## IEEE 802.3 Ethernet Working Group

Subject: Acknowledgment of Liaison Communication and Clarification Request on De-Rating Guidance

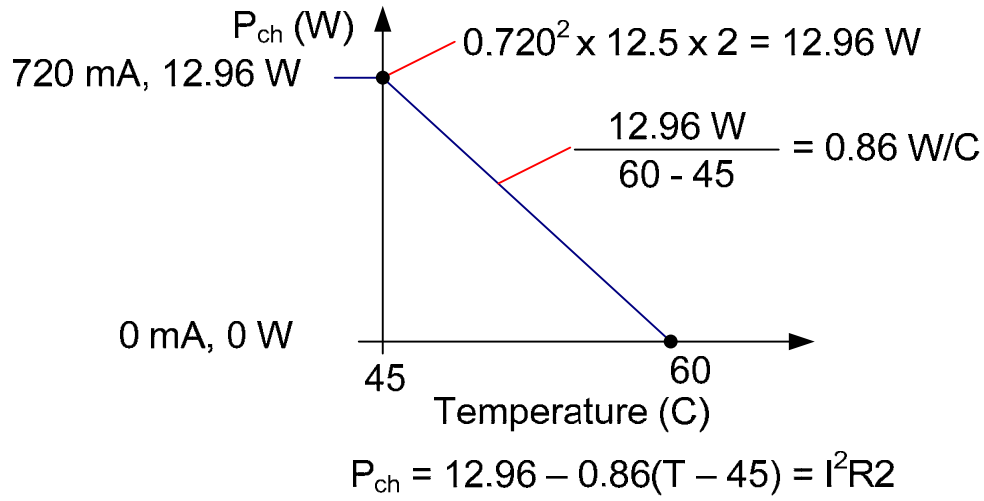
(2) Please see the attached graph. Does this graph accurately reflect your de-rating guidance per the technical contribution
